**Proposed Flat with Permitted Shop and Services and Eating Place
at "Commercial (9)" Zone
Nos. 3-5 San Ma Tau Street, Ma Tau Kok, Kowloon
(Planning Application No. A/K22/47)
Further Information No. 3**

**Proposed Flat with Permitted Eating Place and Shop and Services Uses in “Commercial (9)” Zone,
Nos. 3-5 San Ma Tau Street, Ma Tau Kok, Kowloon
(Planning Application No. A/K22/47)**

Comments forwarded from Kowloon District Planning Office

KEY PLAN

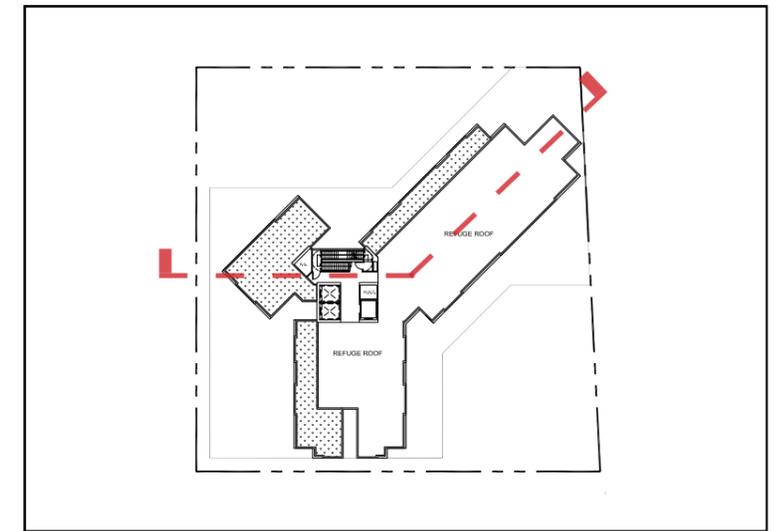
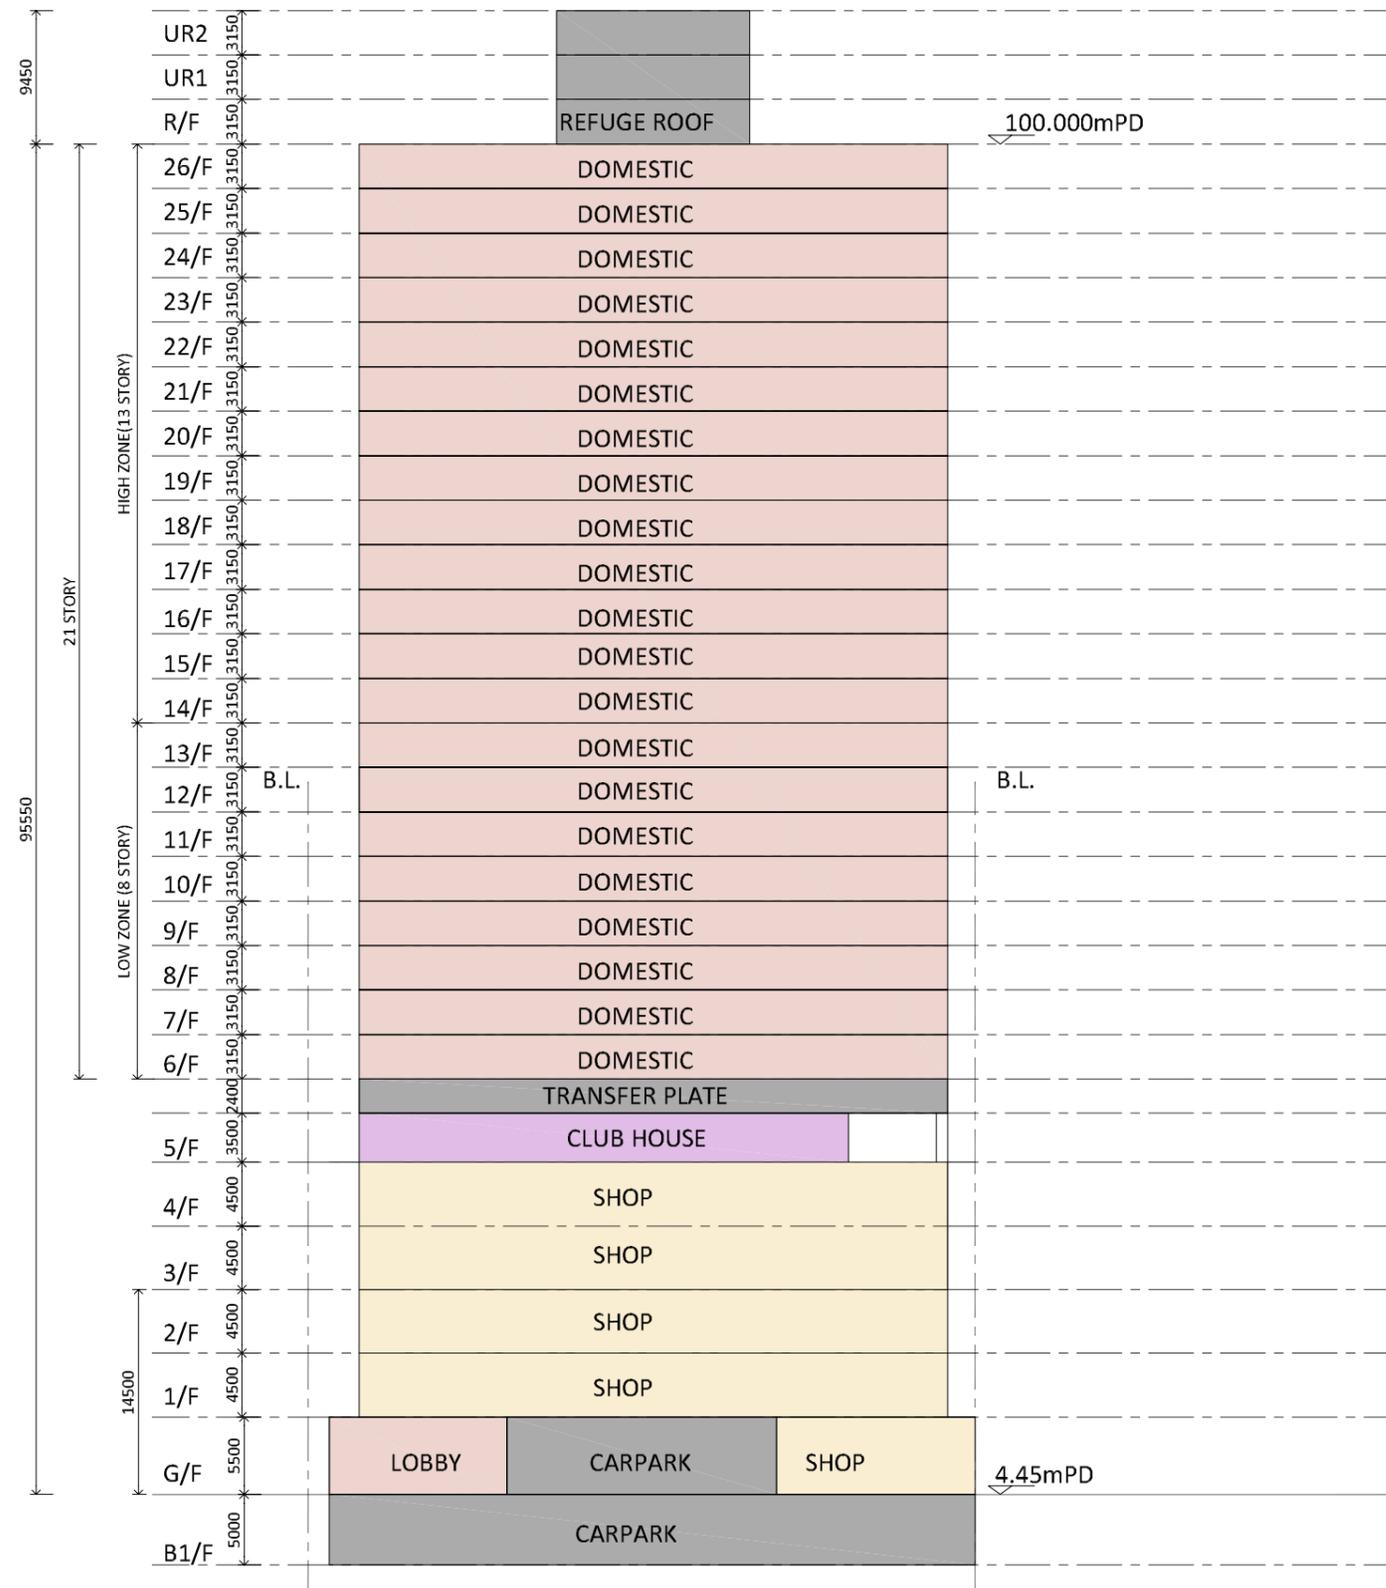
4. For the plans provided this morning for our advanced information, could you please review which key plan is correct?	The section plan with correct key plan is attached (Annex A refers).

Figure: 4.2

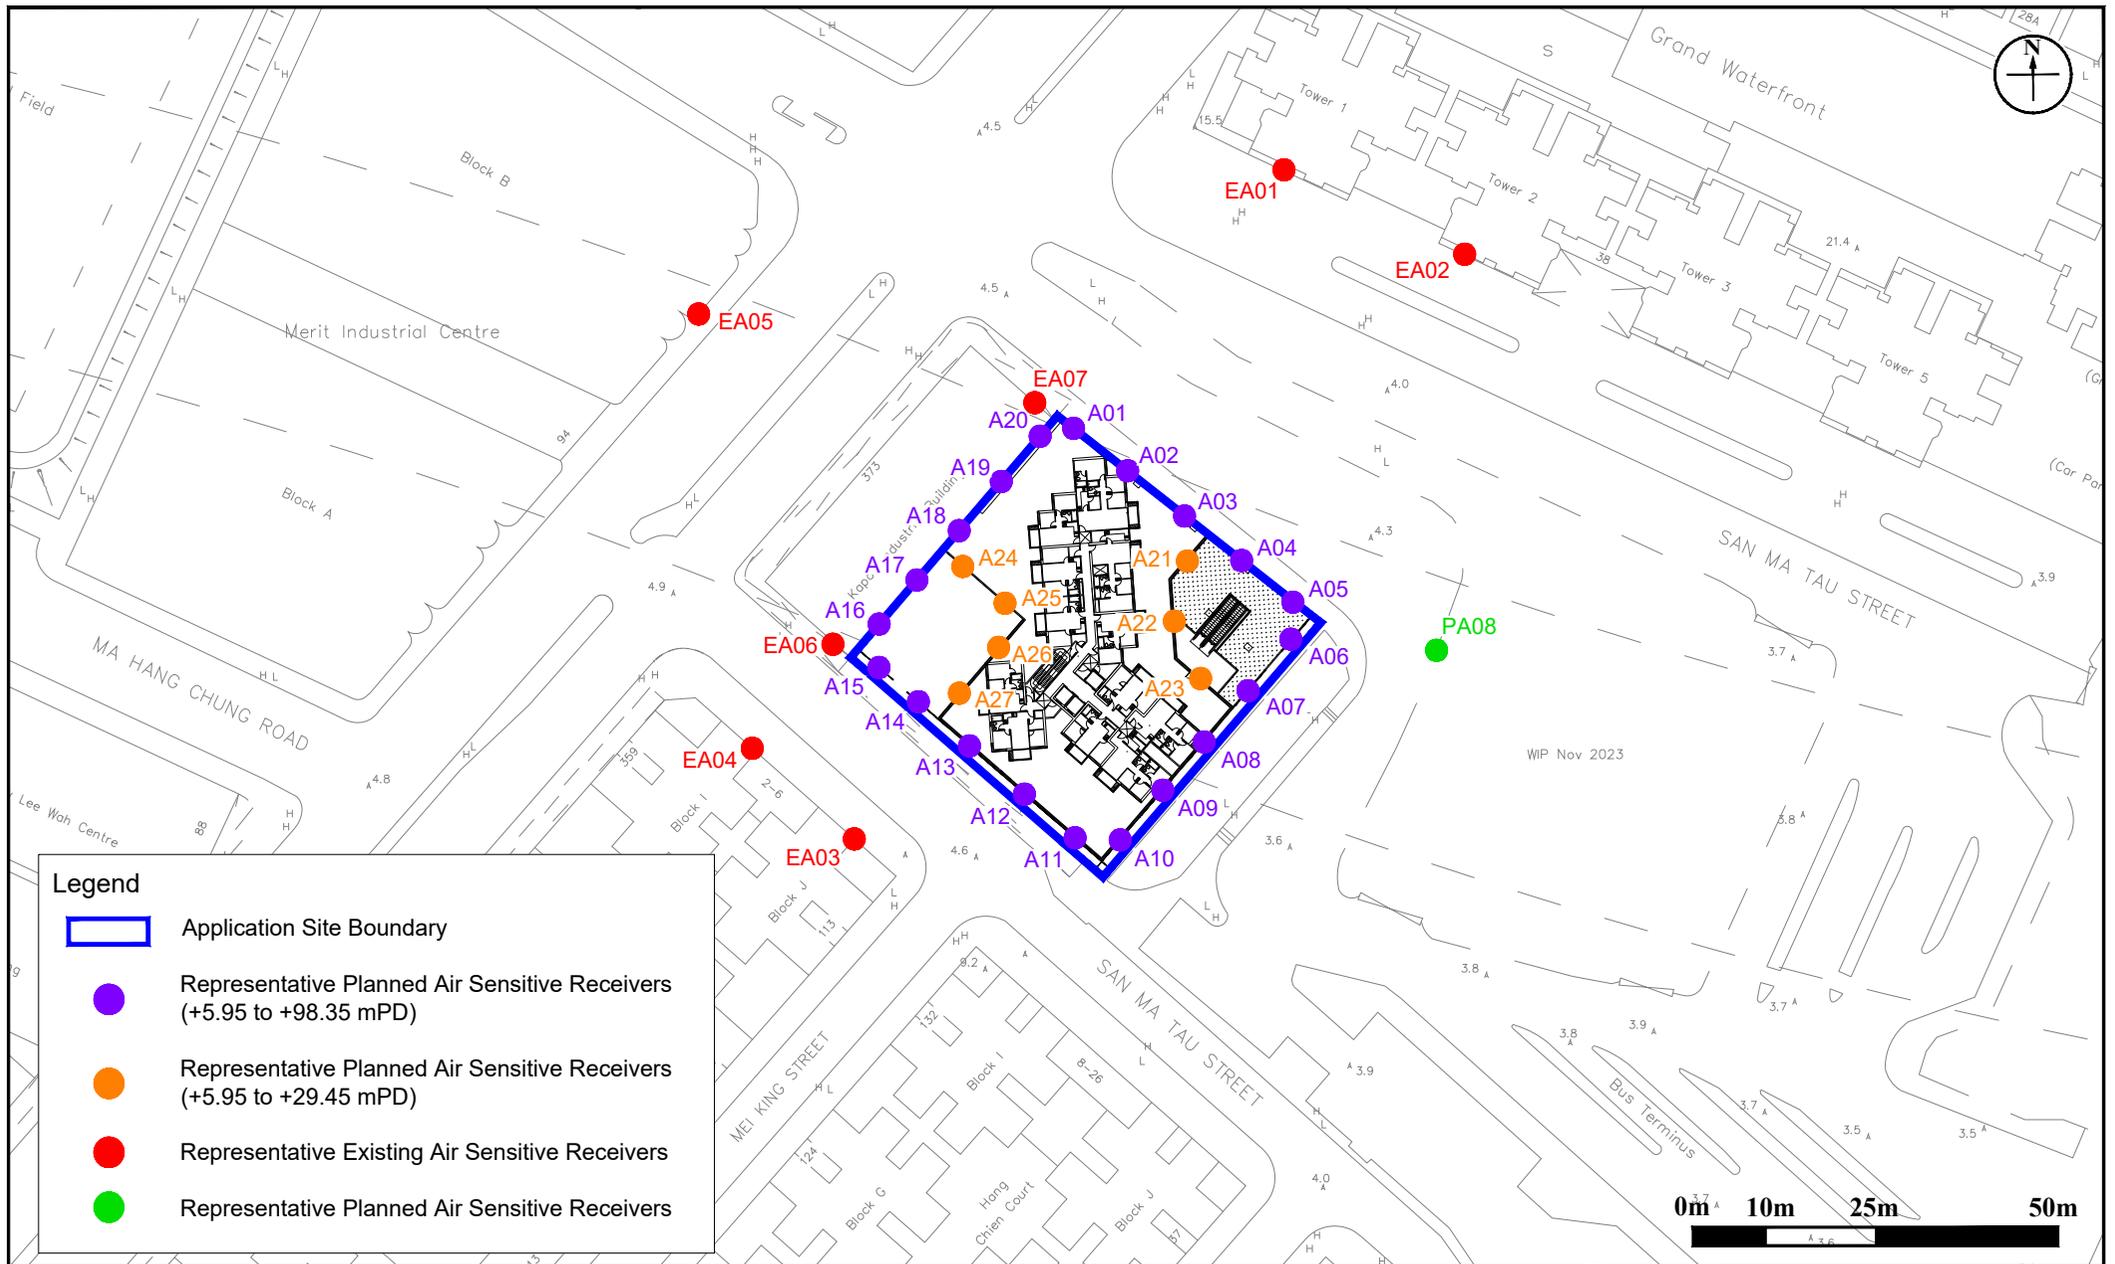
<p>6. Section 4.11.1: In view of the proximity of some ASRs (e.g. Kapok Industrial BLDG with <5m distance) to the Project site, please consider the following mitigation measures:</p> <ul style="list-style-type: none"> • Adopt site hoarding at sufficient height close to those concerned ASRs; • Locate the haul road away from those concerned ASRs; • Avoid dusty works or placing stockpiles near to those concerned ASRs; • Minimization of unpaved, exposed earth by immediate covering/ permanent paving as soon as the works have been completed. 	<p>Section 4.11.1 has been revised.</p>
<p>7. Section 4.12.1: Please also quote Air Pollution Control (Non-road Mobile Machinery)(Emission) Regulation and Air Pollution Control (Fuel Restriction) Regulations.</p>	<p>Section 4.12.1 has been revised.</p>
<p><u>Comments on Vehicular Emission:</u> 8. Section 4.7.8: Please supplement that zero-emission vehicle scenario option has been selected in SAMP v2.1 for calculating open road and portal emission.</p>	<p>Section 4.7.8 has been revised.</p>

Figure: 4.5

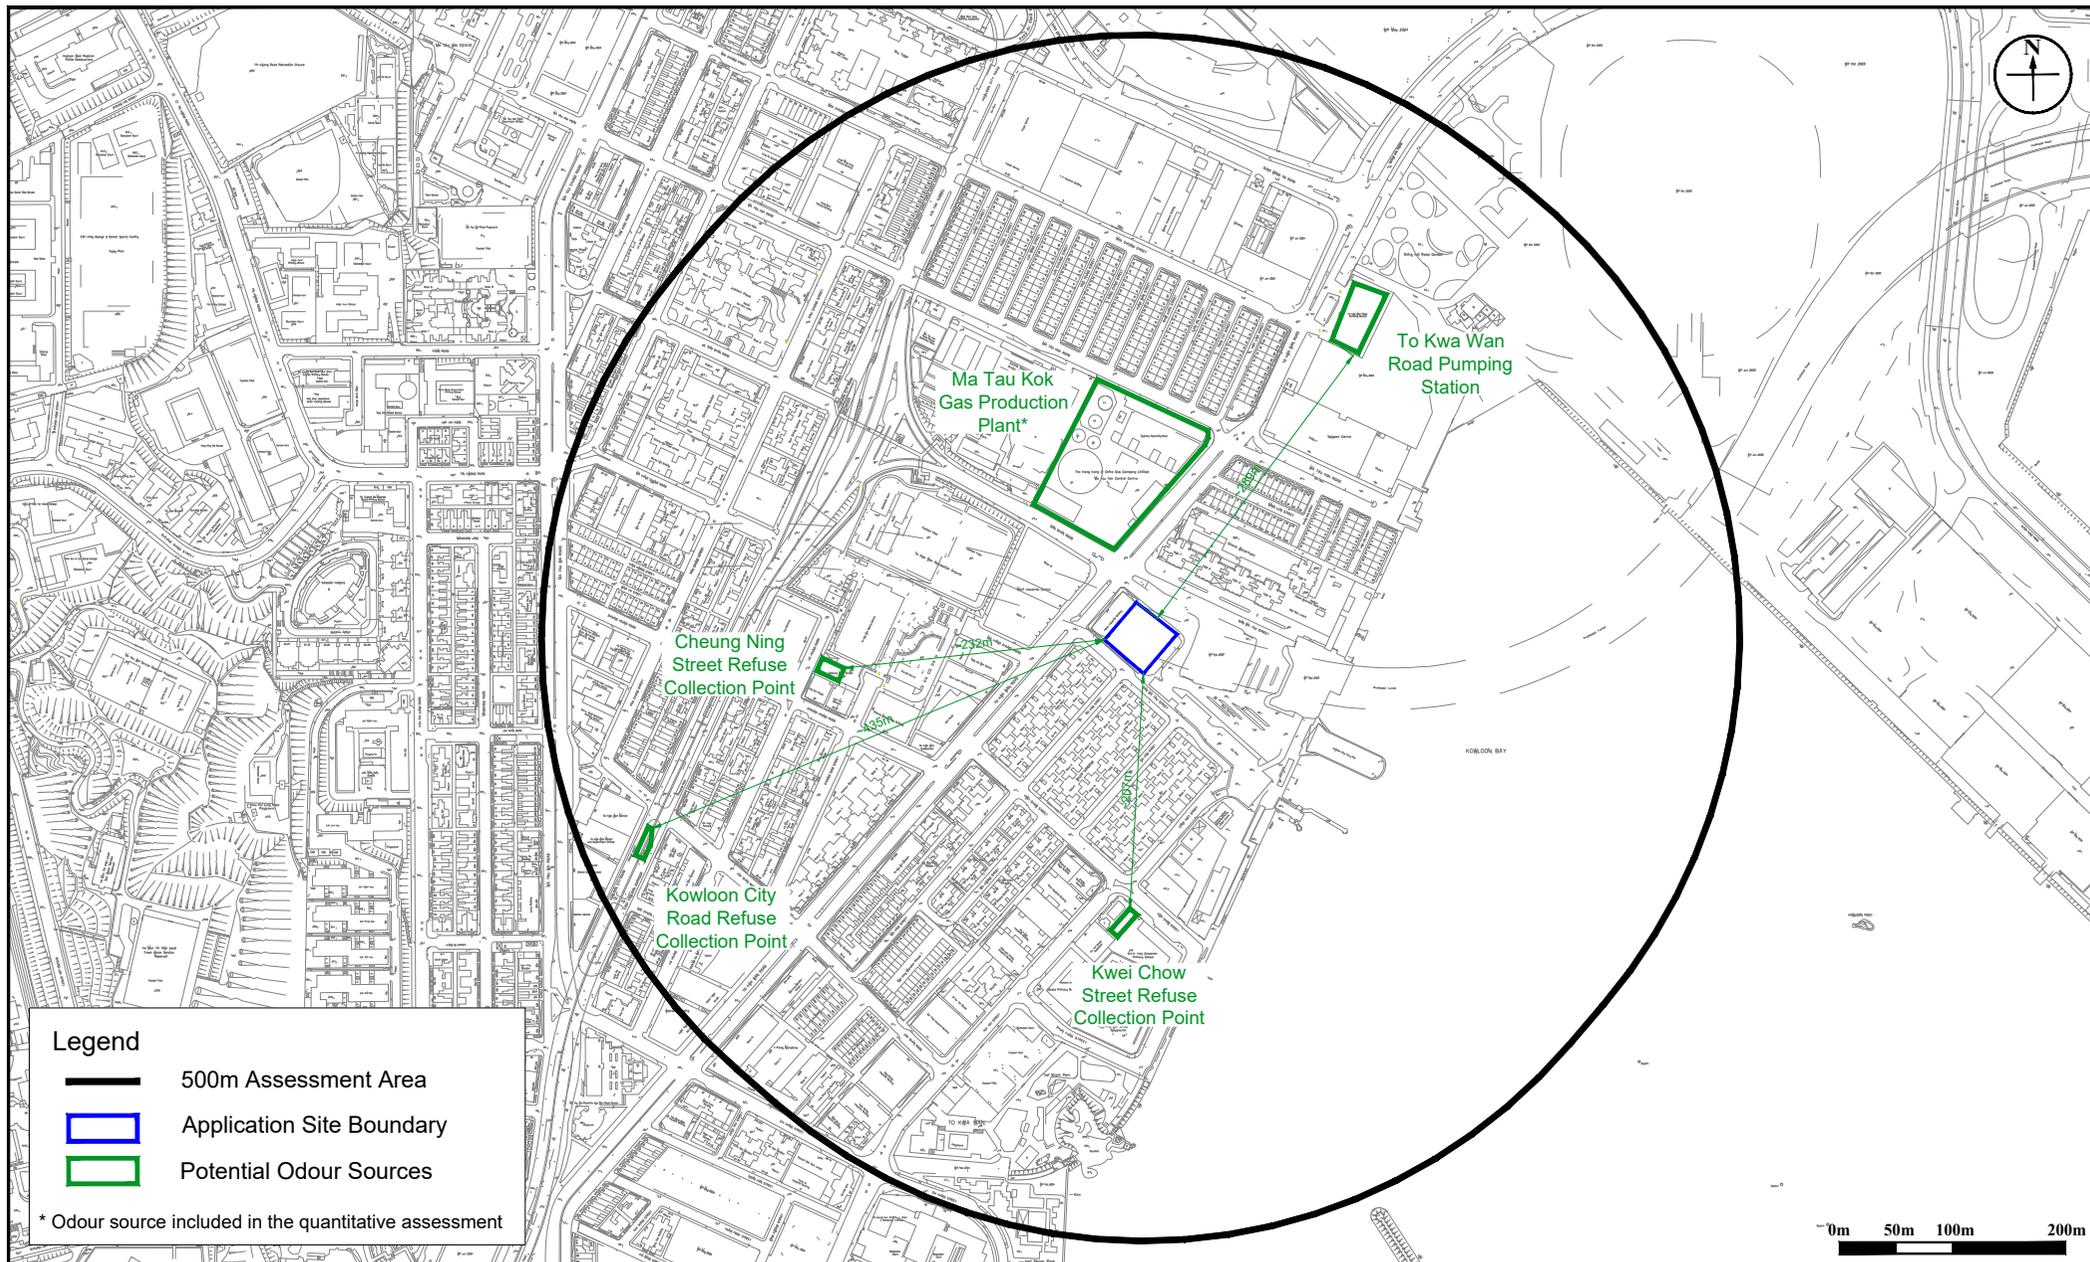
Comments	Responses
<p>from no odour complaint record is being received, please also supplement other reasons such as the distance from the project / presence of high-rise buildings between the site and the pumping station.</p>	
<p>(b) Since EPD only confirms that no odour complaint records for the identified sources in the past 5 years (2020-2024) and it is the odour survey which confirmed there is no odour impact from the sources, please revise the sentence “<i>according to observations during the site visit and information provided by EPD no odour impacts were observed near the four refuse collection points</i>” and discuss the findings from the odour survey and reply from EPD separately.</p>	<p>Section 4.6.11 has been revised.</p>
<p>5. Section 4.7.21: Please supplement justification for the minor differences between ATC 2024 and 2023, e.g. stating the % difference of VKT between 2023 and 2024.</p>	<p>Section 4.7.21 has been revised. Based on the detailed breakdown of the % difference of VKT between 2023 and 2024 is around 0.06%. Hence, it is expected that using the ATC 2023 data will not significantly impact the results of the AQIA</p>

DRAWING TITLE :
 LANDSCAPE MASTER PLAN (5/F)

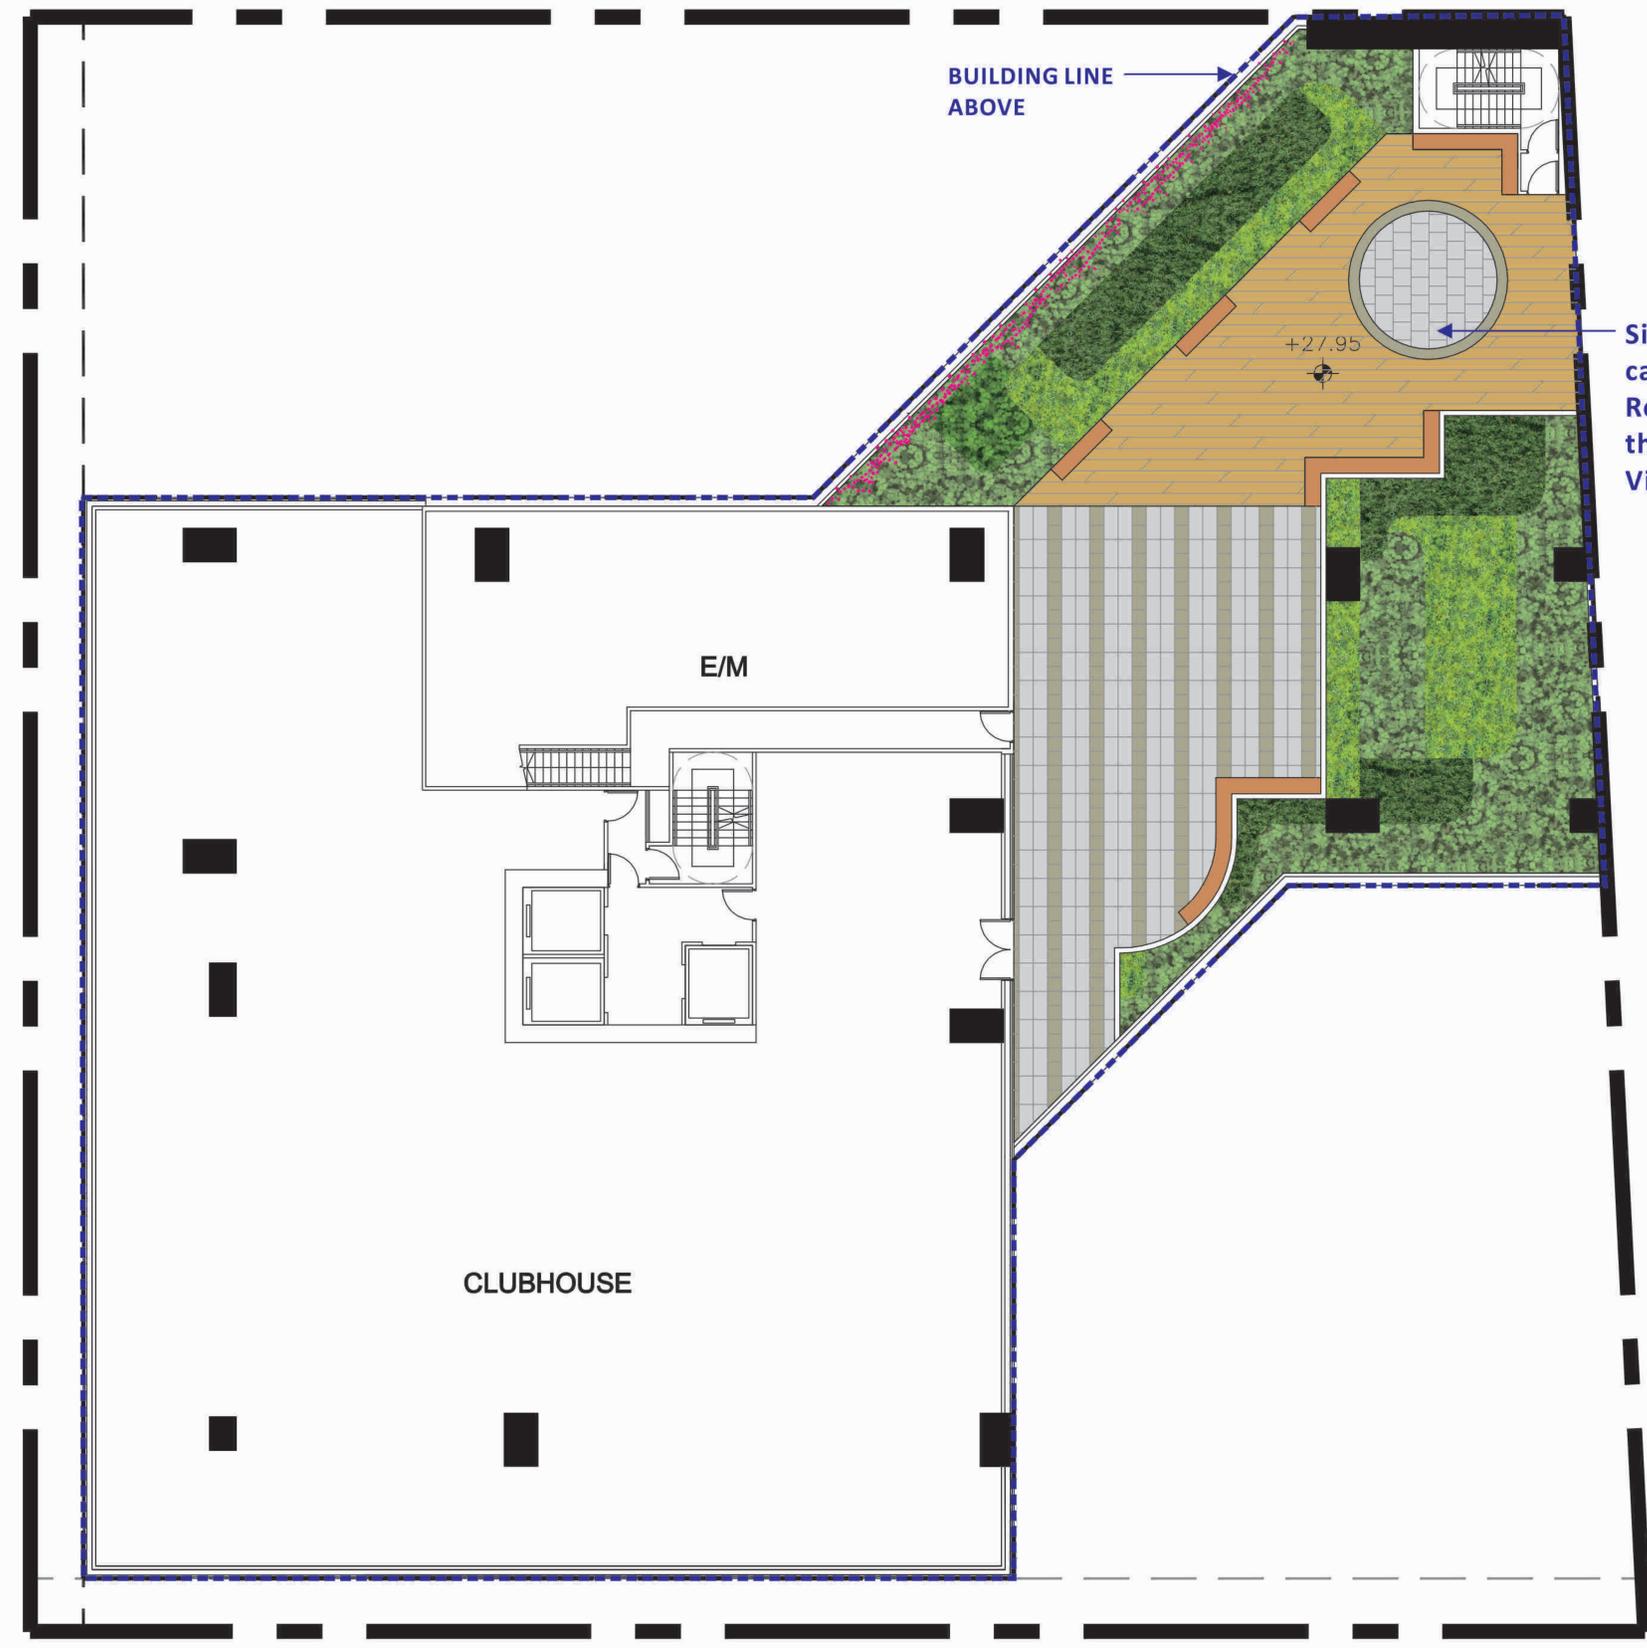
Comments from Planning Department (Received on 24 February 2026) (Contact Person: Ms Helen IP; Tel.: 2231 4971)	
1. The planter layout of the 5/F as shown on Landscape Master Plan (5/F) does not tally with the "Fifth Floor Plan" in the Architectural Drawings, please clarify which one shall be made referenced to.	The 5/F layout of the Landscape Master Plan has been updated (Annex E refers).
